Filed: January 24, 2005 Serial No.: 10/552,656

**REMARKS**

A HOOK ENDED STEEL WIRE NETTING
Leng, Luhao - 1991.72258
Serial No. 10/522,656
Greer, Burns & Crain, Ltd. (Lawrence J. Crain)
Annotated Sheet 2 of 6 (312) 360-0080

Figure 3

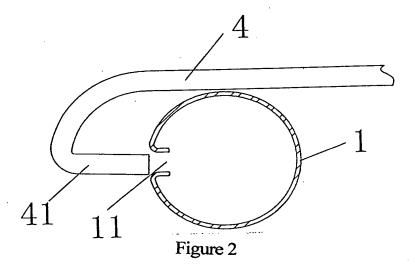
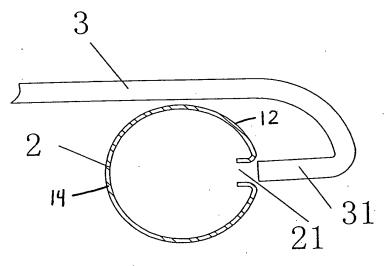
Please approve the drawing changes shown in red on the attached annotated Fig. 3, and replace them with replacement Fig. 3.
